### Monitoring Year 4 Report Final 2023

Rough Horn Swamp Restoration Site Monitoring Year – MY04 RFP #16-006310 DMS Site ID Number 97005, DMS Contract 6596 SAW-2015-00952 and NCDEQ DWR 2015-0903

Rough Horn Swamp II Restoration Site RFP #16-007337 DMS Site ID Number 100053, DMS Contract 7514 SAW-2016-02026 and NCDEQ DWR 2015-0903

Date:	February 22, 2024
To:	Emily Dunnigan, DMS Project Manager
From:	Adam Spiller, Project Manager
	KCI Associates of North Carolina, PA
Subject:	MY-04 Monitoring Report Comments
	Rough Horn Swamp DMS #97005, Contract 6596
	Rough Horn Swamp II DMS #100053, Contract 7514

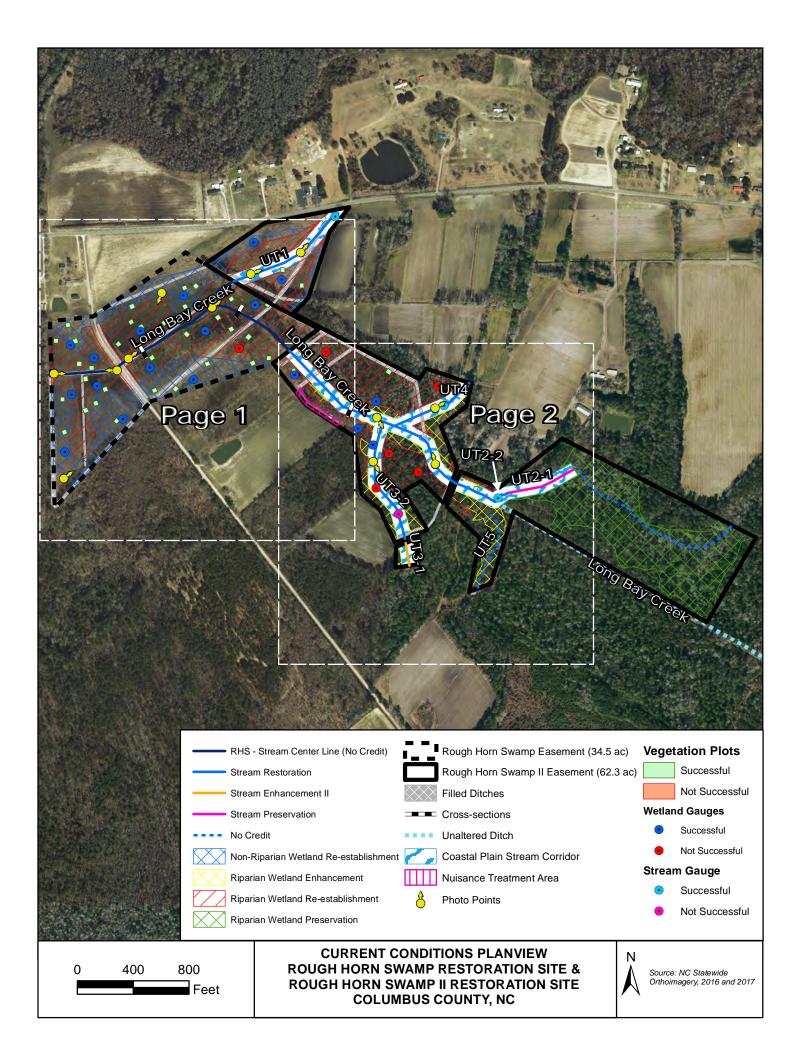
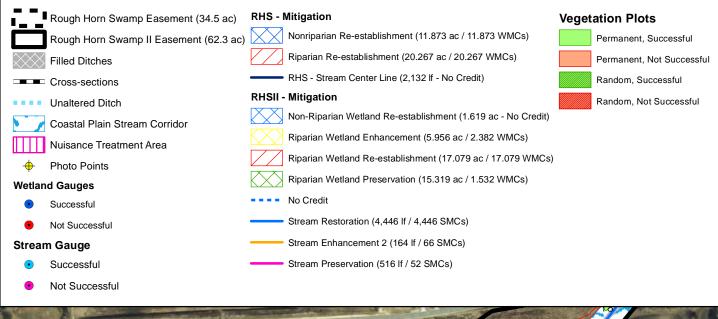
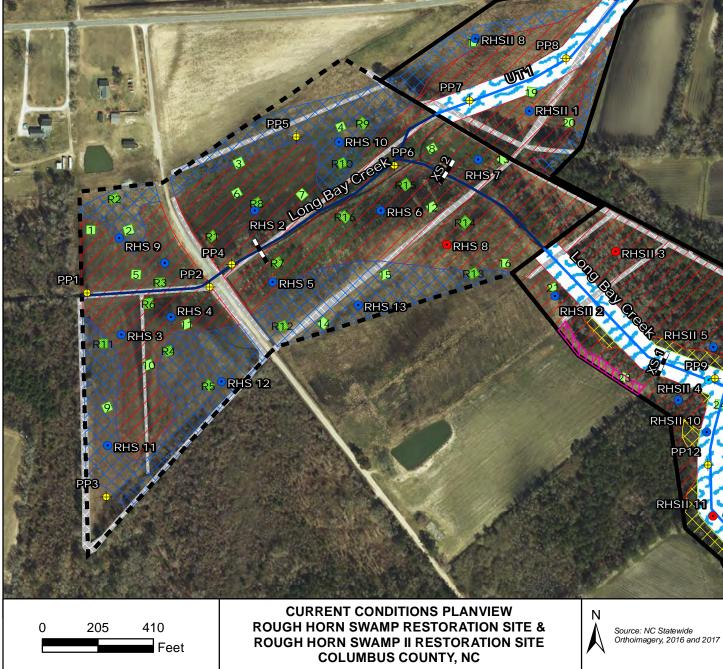
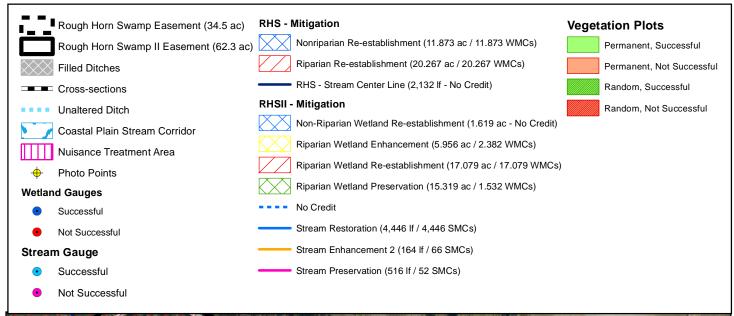
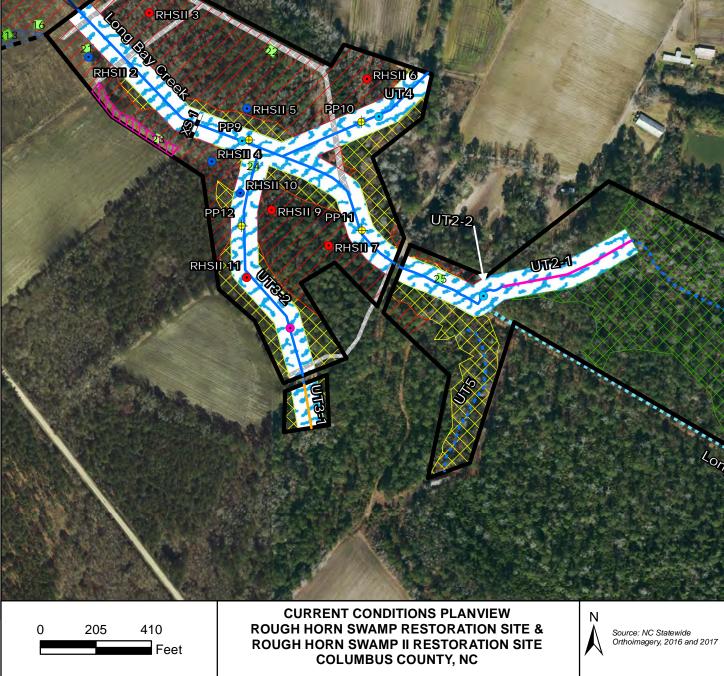
3. CCPV: Please update groundwater gauge color coding to match MY4 data. Ex: RHSI 11 met criteria, but it's shown as not meeting. *KCI Response: This error has been corrected.*

4. CCPV: Please label RHSII 9. *KCI Response: This has been corrected.*
